STAFF REPORT

SUBJECT: Stonehill Crossing No. 1

FP-2024-0020

Final plat consisting of two (2) building lots on 16.06-acres of land in the R-4 and R-8 zoning districts. This is the first phase of Stonehill Crossing Subdivision.

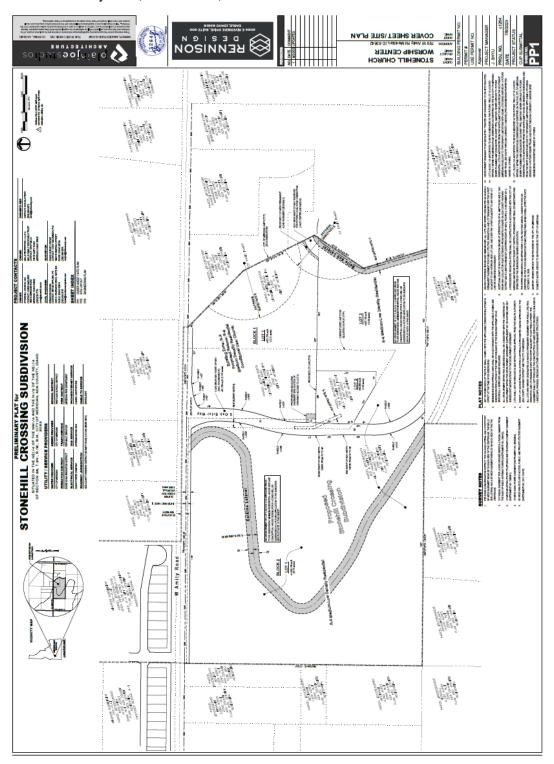
The preliminary plat included a condition (i.e. #2.1g) for a local public street to be provided off S. Oak Briar Way between Lots 1 and 2, Block 1 for access to these lots instead of a direct access to the collector street. It was required to extend at a minimum, to the east boundary of Lot 2, Block 1 and to extend to the south with future re-subdivision of Lot 3, Block 1. Based on the City's requirement, ACHD also included conditions (i.e. #10 & #11) that required a local street to be constructed between these two lots and extend to the site's east property line. Since

that time, ACHD has determined they will *not* allow a local street in this location. After much discussion with ACHD on this matter, Staff requests Council approval of a change to the access in this location to allow a private driveway access via S. Oak Briar Way on Lot 1, Block 1 with a temporary ingress-egress easement to Lot 2, Block 1. When an alternate access is available for Lot 2 with development of Lot 3, Block 1, the access easement should terminate, and access should be provided via a local public street.

B. Final Plat (dated: 12/13/24)

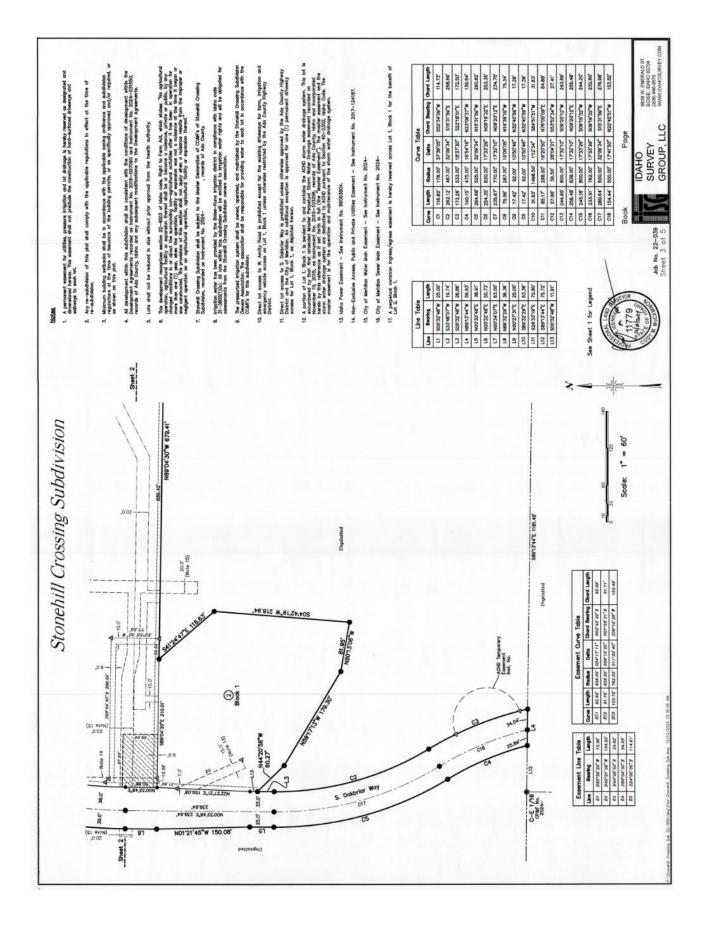
- 3. Prior to submittal for the City Engineer's signature, have the Certificate of Owners and the accompanying acknowledgement signed and notarized.
- 4. The final plat shown in Section V.B prepared by Idaho Survey Group, LLC, stamped on 12/13/2024 by Cody McCammon, shall be revised as follows:

- a. Note #5: "Lots shall not be reduced in size without prior approval from the health authority and the City of Meridian."
 - b. Note #7: Include the recorded instrument number of the CC&R's.

- c. Note #10: "Direct lot access to W. Amity Road is prohibited except for the existing driveways for farm, irrigation and emergency vehicle access on Lot 1, Block 1 unless otherwise restricted by the Ada County Highway District."

- d. Note #11: "Direct lot access to S. Oakbriar Way is prohibited unless otherwise approved by the Ada County Highway District and the City of Meridian. An additional exception is approved for one two (4 2) permanent driveway accesses for Lot 1, Block 1, as depicted hereon."

- e. Note #15: Include the recorded instrument number of the City of Meridian water main easement.
 - f. Note #16: Include the recorded instrument number of the City of Meridian sewer main easement.

- g. Note #17: "A perpetual common temporary ingress/egress easement is hereby reserved across Lot 1, Block 1 for the benefit of Lot 2, Block 1 until such time as an alternate access is available for Lot 2, Block 1, at which time the easement shall cease and the access driveway on Lot 2, Block 1 shall be removed."

- h. Include the phase number in the subdivision name.
 - i. Include the recorded instrument number of the ACHD temporary easement graphically depicted on Sheet 3.

- j. Include the CP&F No. on Sheet 1.
 - k. Depict a minimum 20-foot wide street buffer along S. Oakbriar Way, a collector street, and a minimum 25-foot wide street buffer along W. Amity Rd., an arterial street, in a common lot or on a permanent dedicated buffer easement labeled as such, with a note that it will be maintained by the property owner, homeowner's association or business owner's association (as applicable) as set forth in UDC 11-3B-7C.2a. The buffer along W. Amity Rd. shall be measured from the ultimate curb location as anticipated by ACHD.

C. Landscape Plan (dated: 12/18/2024)

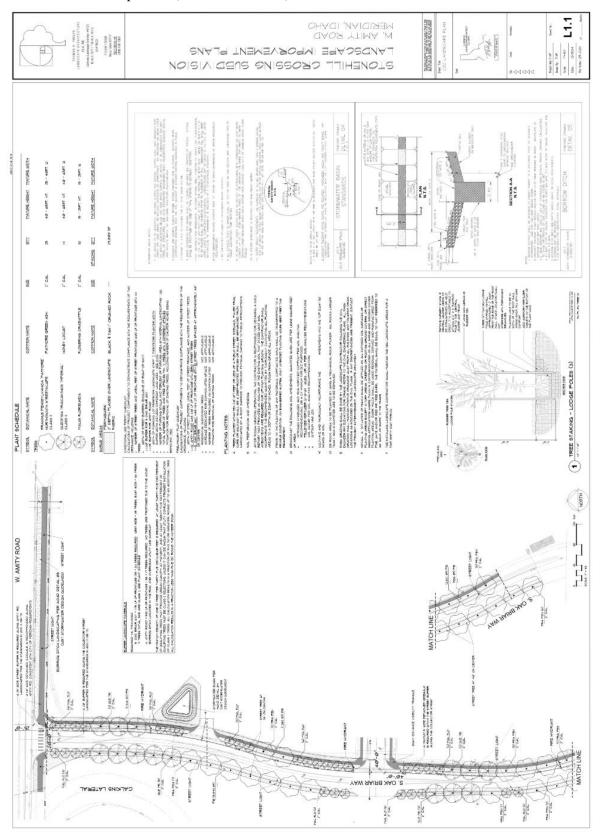
- 5. The landscape plan shown in Section V.C. dated 12/18/24, shall be revised as follows:
 - a. Depict the right-of-way dedication for the multi-lane roundabout planned at the W. Amity Rd./Oak Briar intersection consistent with the Master Street Map; and the additional right-of-way for W. Amity Rd., as required by ACHD.

- b. Widen the street buffer along S. Oak Briar Way to 20-feet and the street buffer along W. Amity Rd. to 25-feet and depict landscaping in accord with the standards listed in UDC 11-3B-7C.3. Street buffers shall be measured from the back of curb or the ultimate curb location as anticipated by ACHD where the street is anticipated to be widened.

- i. Where the buffer is encumbered by easements or other restrictions (i.e. overhead utility line along Amity Rd.), the buffer area shall include a minimum five-foot wide area for planting shrubs and trees per UDC 11-3B-7C.1b; or, Class I trees (i.e. ornamental trees) may be planted if allowed by the utility company.

- ii. All street buffers are required to be planted with a variety of trees, shrubs, lawn or other vegetative ground cover shrubs should be added.
 - iii. Lawn and other grasses requiring regular mowing shall comprise no more than 65% percent of the vegetated coverage of the landscape buffer. This maximum area excludes landscaped parkway with trees. All other vegetated coverage shall be mulched and treated as planting area for shrubs or other vegetative cover. Areas along required walls and closed vision fences should generally be reserved for planting beds with a minimum of one (1) shrub per seven (7) lineal feet of frontage.

- iv. The calculations table should be updated to reflect compliance with the aforementioned standards, including required vs. provided number of trees, percentages and tree classifications (i.e. Class I, II or III).

- c. Depict the edge of pavement for Amity Rd. on the plan. If the unimproved street right-of-way is 10-feet or greater from the edge of pavement to edge of sidewalk or property line, the developer shall maintain a ten-foot compacted shoulder meeting the construction standards of the transportation authority and landscape the remainder with lawn or other vegetative ground cover per UDC 11-3B-7C.5.

- d. Depict the location of the emergency access driveway via W. Amity Rd. on Lot 1, Block 1 and label it as such.
- 6. All existing structures that do not comply with the setbacks of the R-4 zoning district in UDC Table 11-2A-5 shall be removed from the site prior to submittal of the final plat for City Engineer signature.
